FOR: HVAC Replacement
FFA Leadership Center Recreation Hall
Kentucky Department of Education
Hardinsburg, Kentucky

ADDENDUM NO. One (1)

ADDENDUM NO. 1

TO: All Plan Holders
FROM: Studio Kremer Architects
PROJECT: Future Farmers of America Leadership Camp
RECREATION BUILDING
ska# 2023-33.7

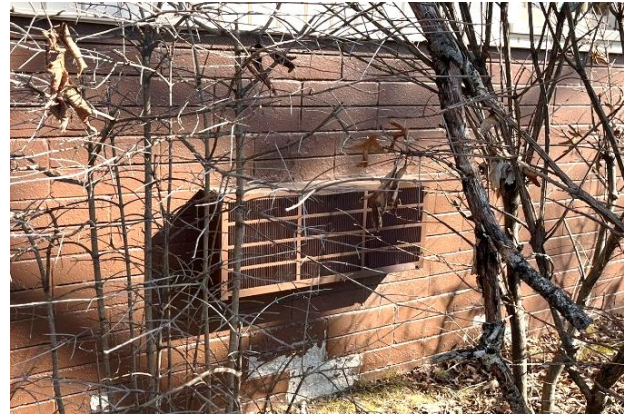
Item No. 1:

Where demolition documents indicate that plumbing or equipment is removed at floor area, cut any connections to below finished floor and fill voids with grout, troweled smooth.

Leave unfinished at exposed concrete floor areas.

If finished floor material is present, prep and install new flooring to match adjacent.

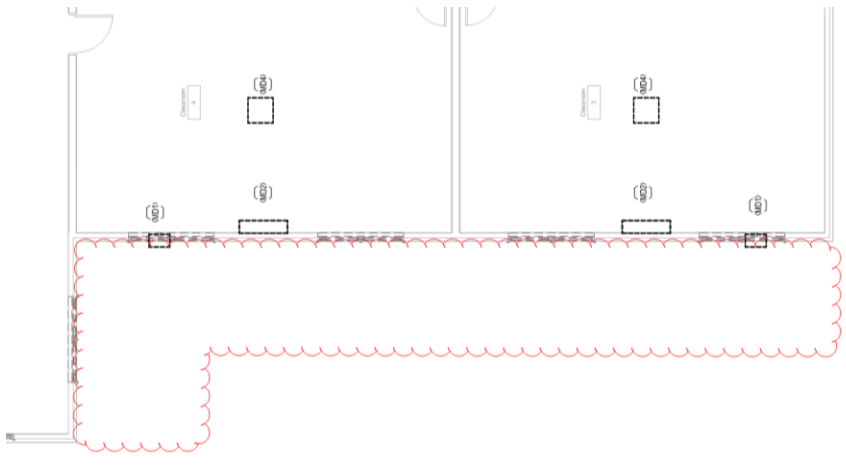
Item No 4: Reference Section 09 90 00 – Painting

1. Where fan(s) or other equipment is indicated to be removed, fill holes with wood filler, prep/sand, and paint exposed area.

2. Where lighting removed / replaced, fill any exposed holes with wood filler, prep/sand area, and paint any areas not covered by new fixtures.

1 FIRST FLOOR PLAN - MECHANICAL DEMOLITION
SCALE: 3/16" = 1'-0"

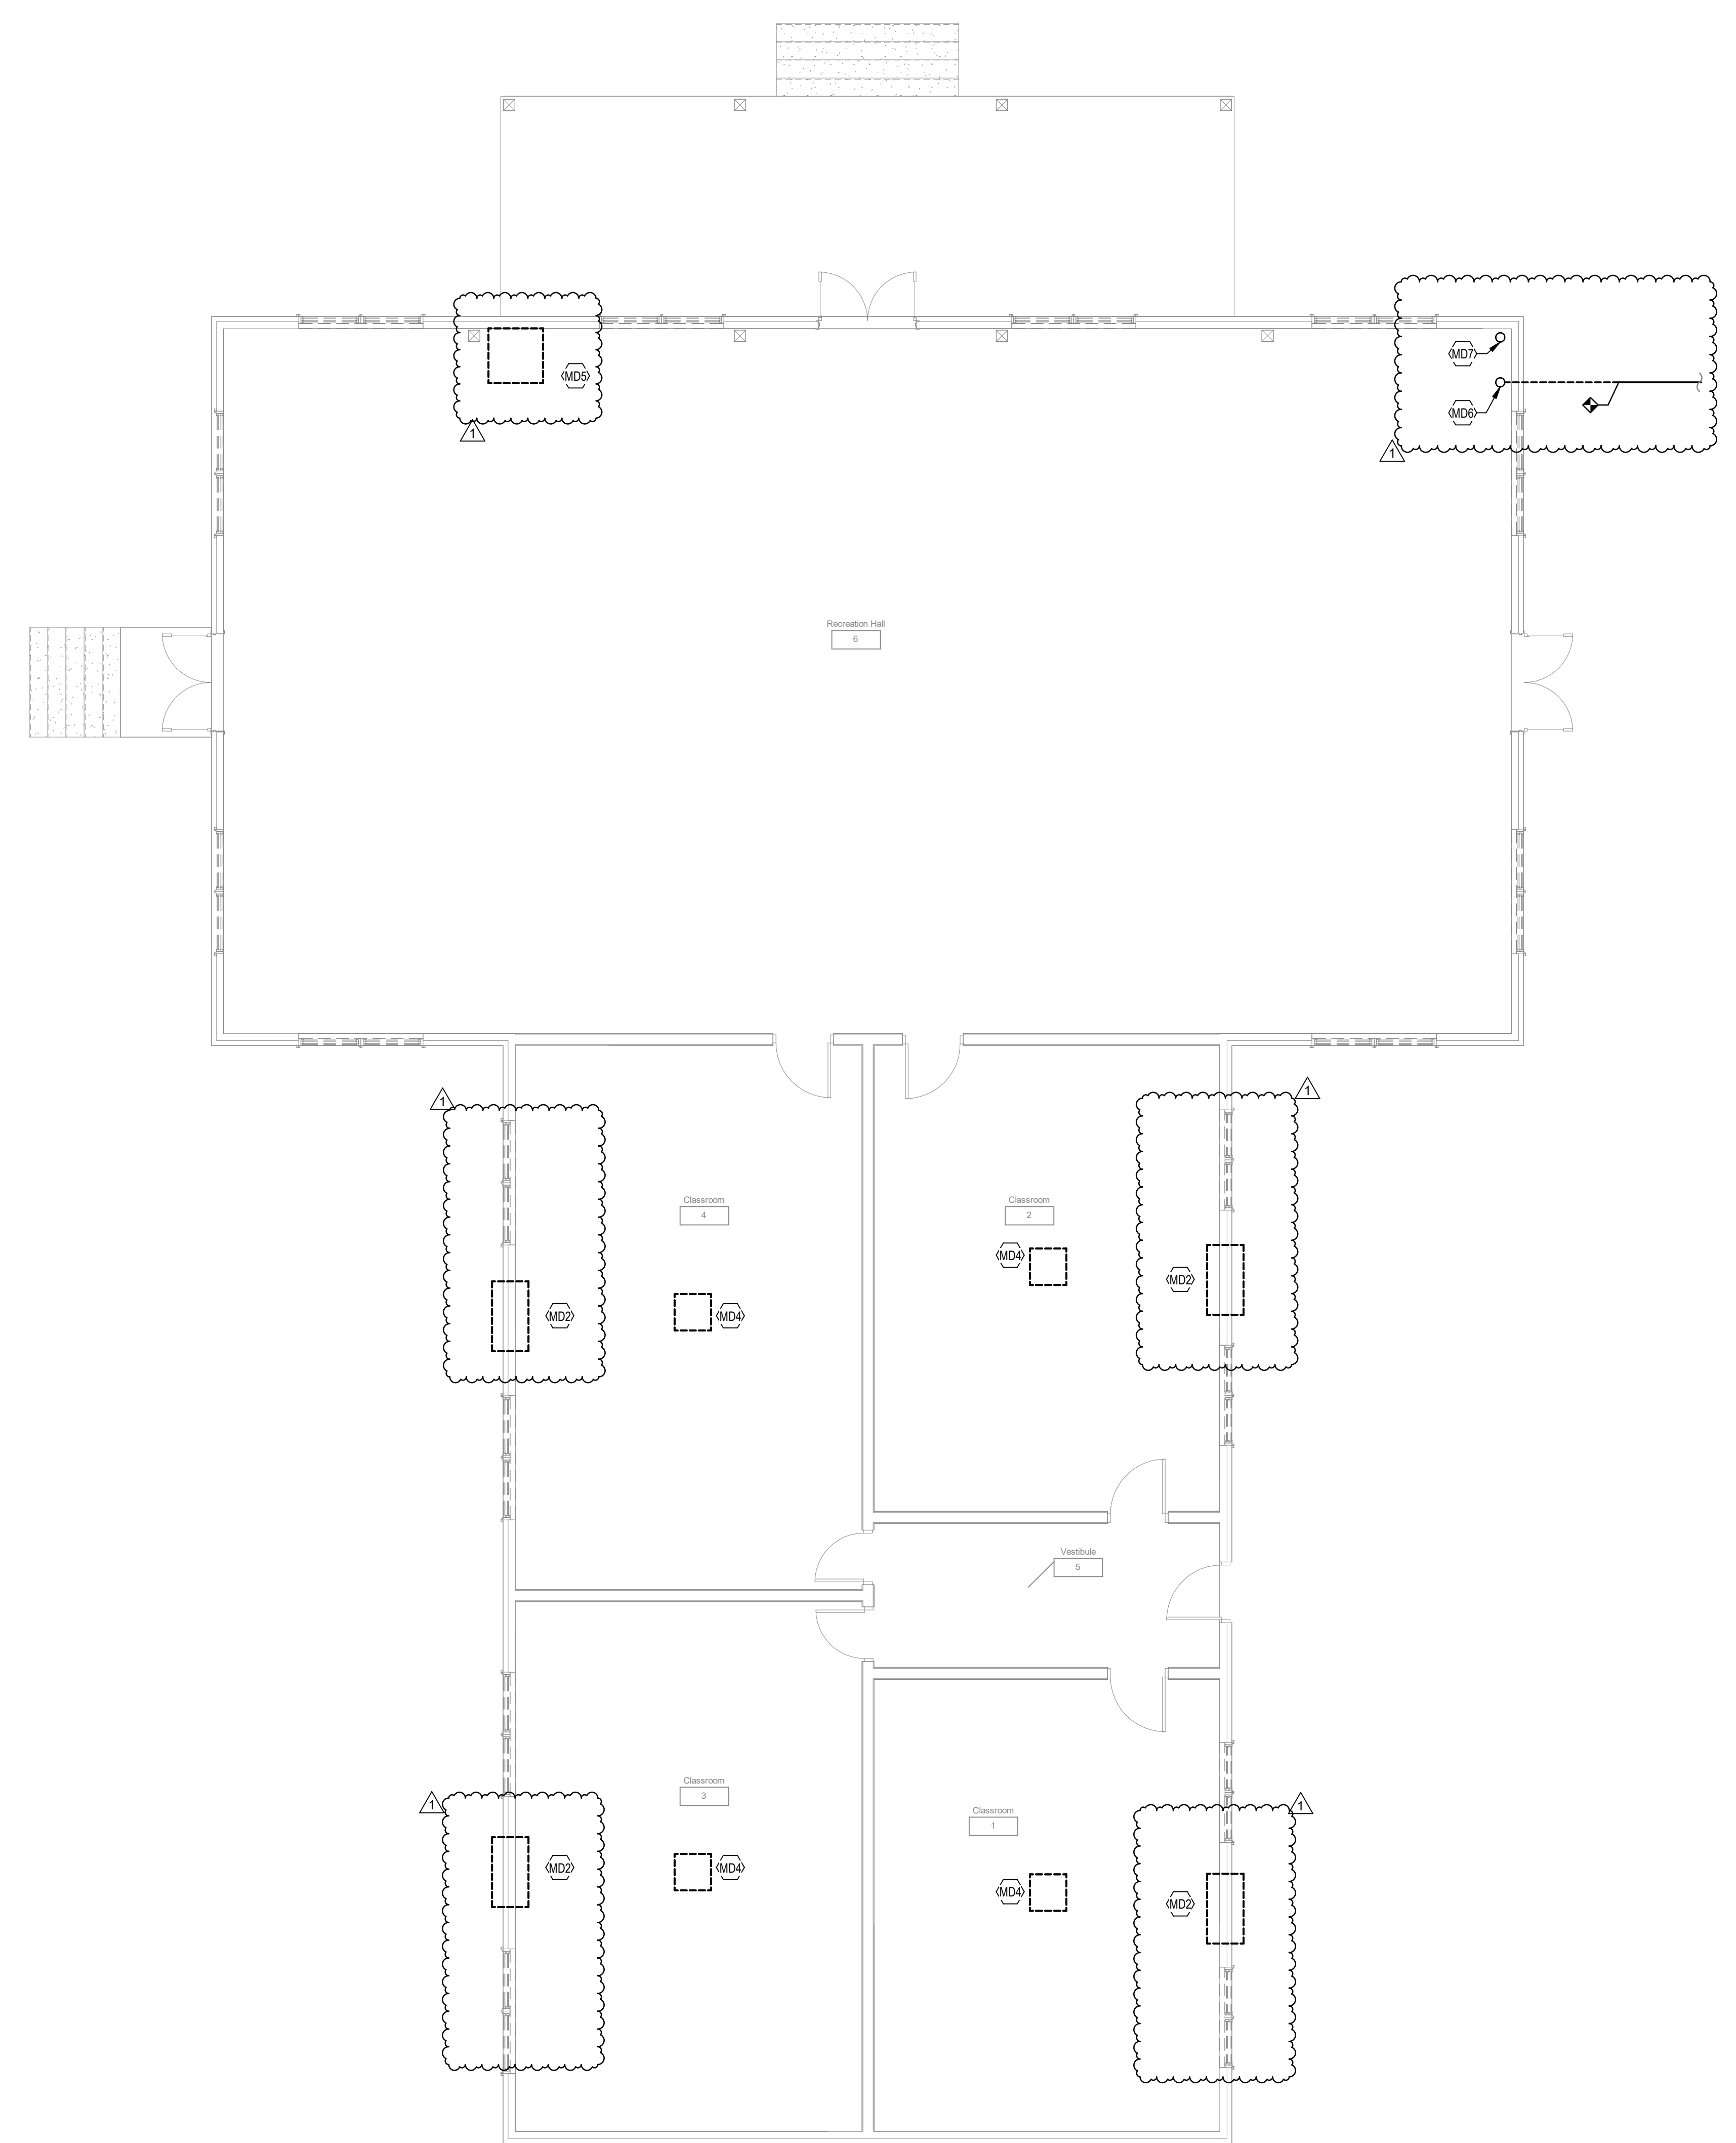
Sheet #	Sheet Title	Noted Update
M200	Recreation Hall Mechanical Demolition	<ol style="list-style-type: none">1. Window AC units have already been removed; no longer in demolition scope.2. Radiator units go through wall and keynote added for concrete infill in open spaces3. Circulating fan to be removed in recreation hall4. Water line to be cut and capped 5 ft away from building.5. Added keynote to cap existing roof vents/holes.
M201	Recreation Hall Mechanical New Work	<ol style="list-style-type: none">1. Modified condensing unit layout to keep existing tree2. Denoted condensate pipe sizes3. Updated condensate pipe keynote for spilling on grade
M300	Mechanical Sections	<ol style="list-style-type: none">1. Modified condensing unit layout for coordination around existing tree.

5 WALL MOUNTED UNIT DETAIL
NO SCALE

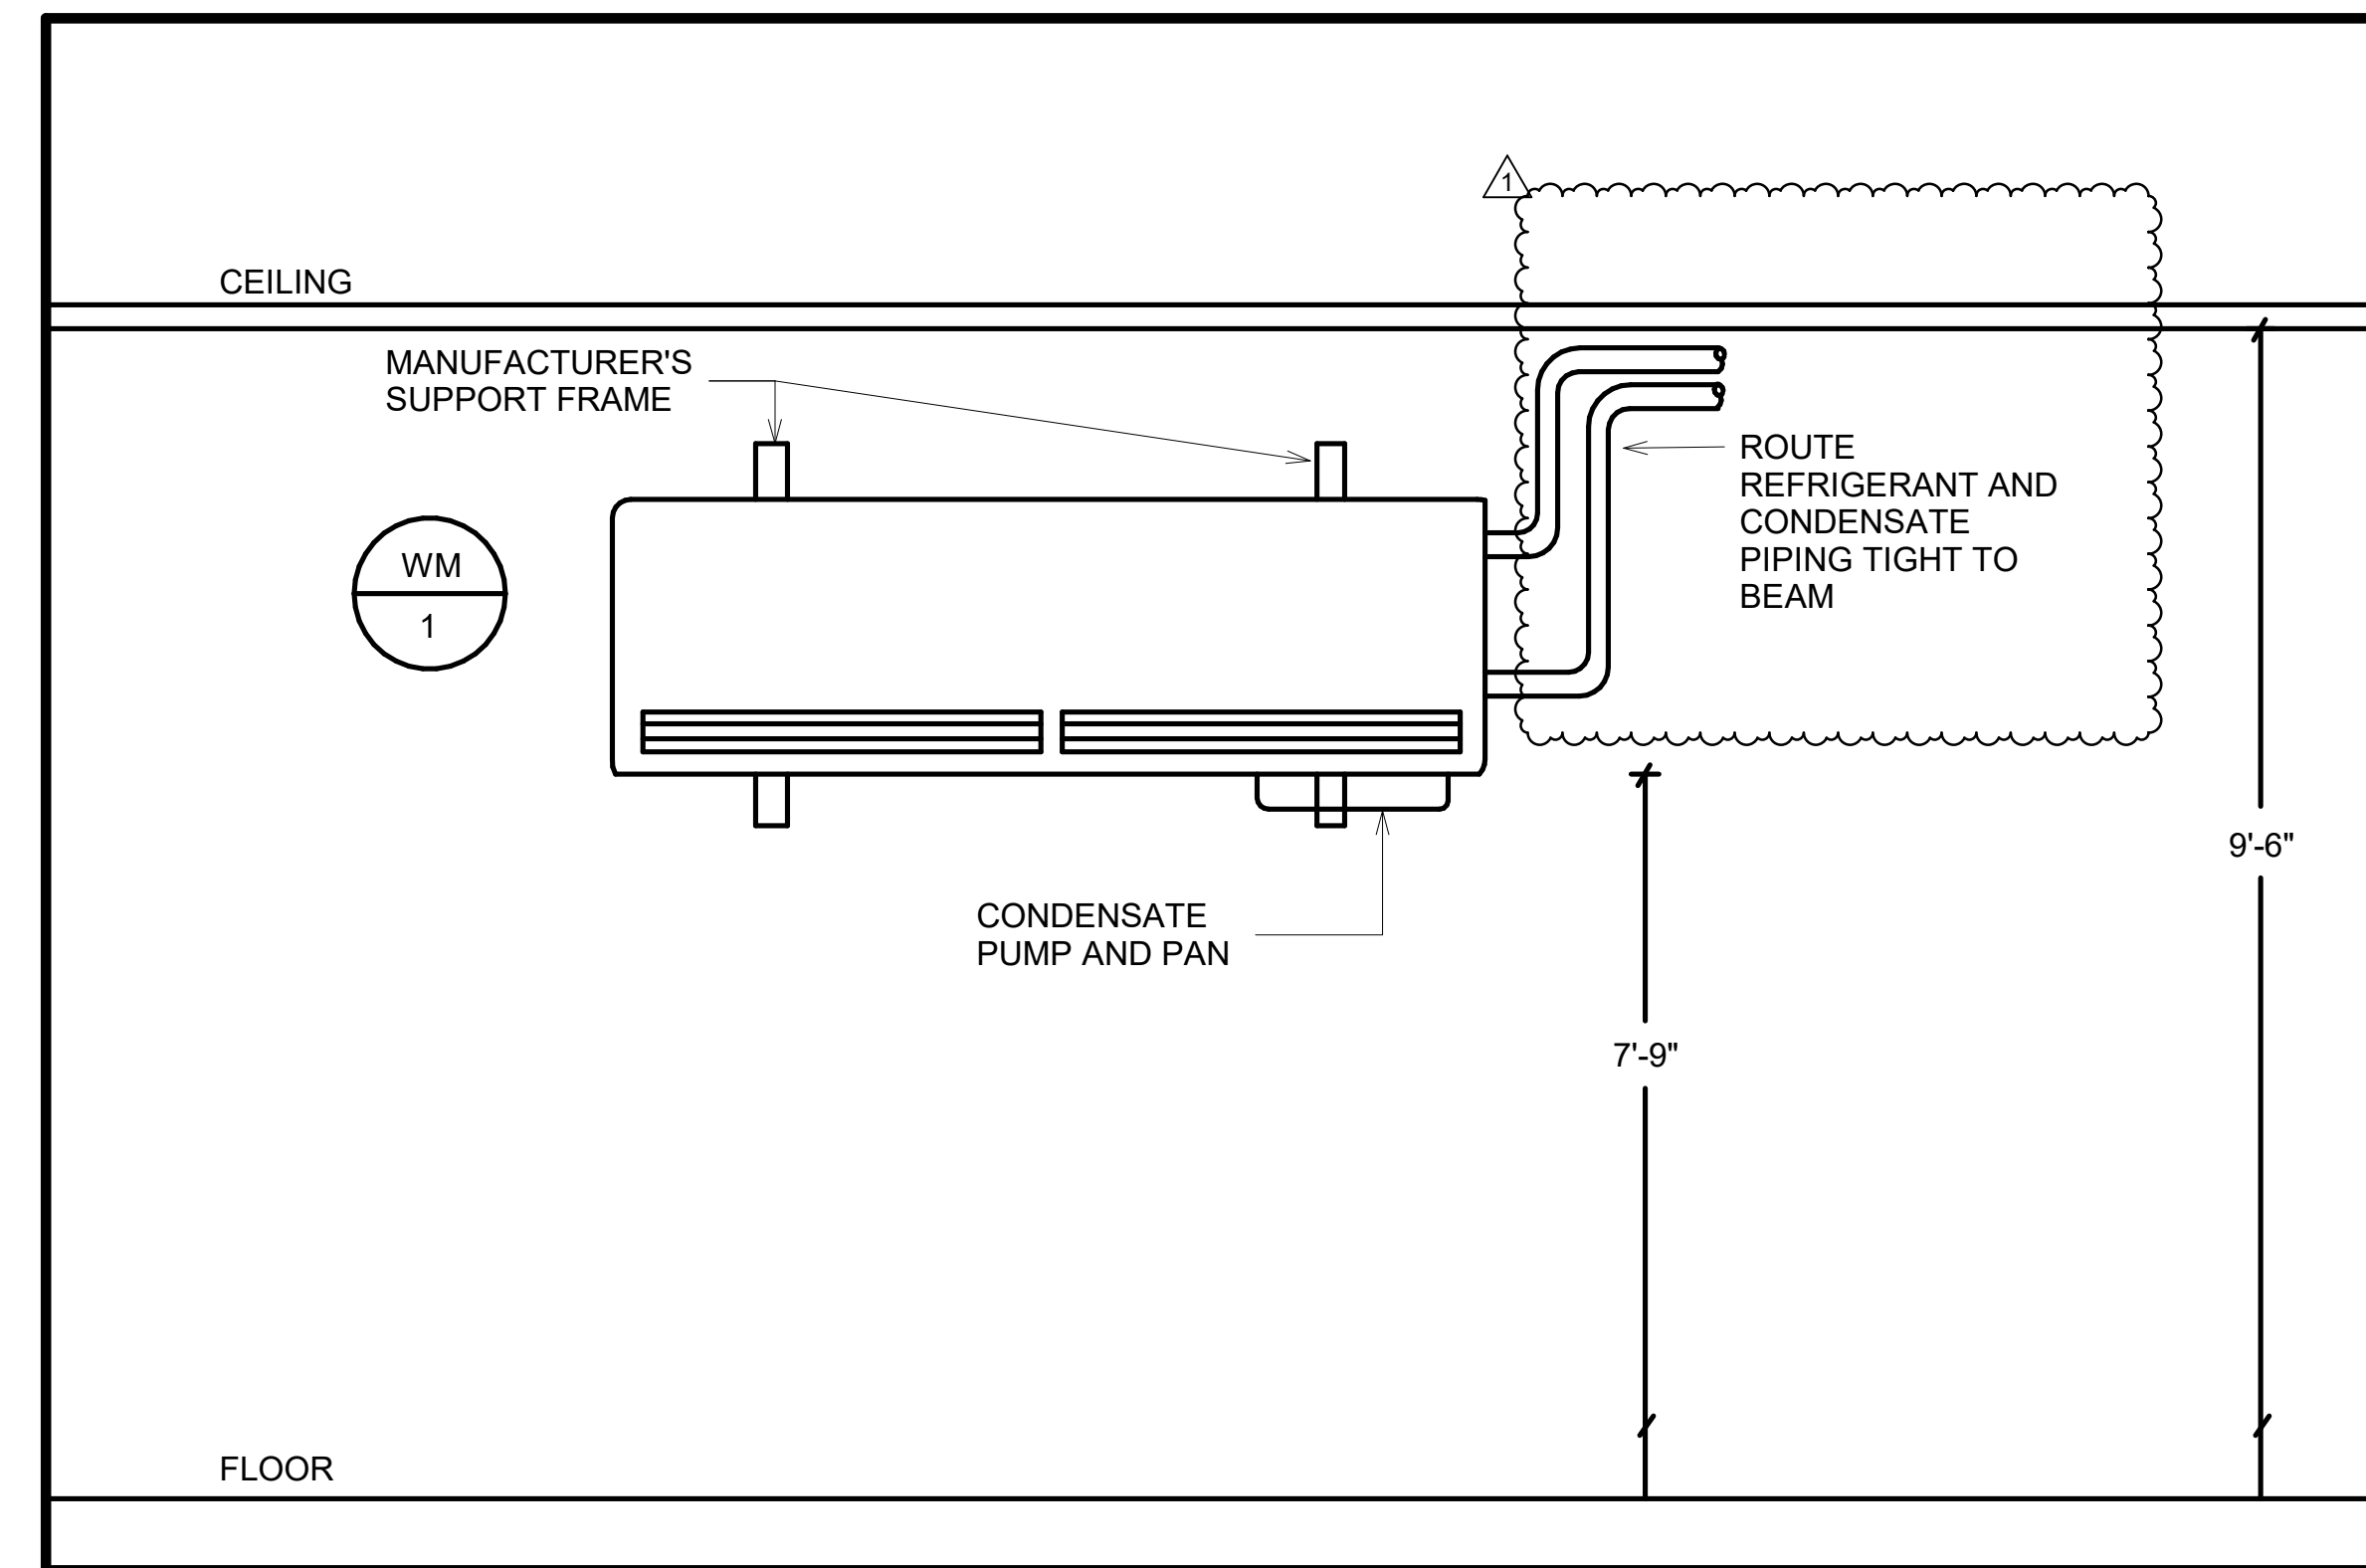
M400	Mechanical Details	1. Updated wall mounted unit detail pipe routing
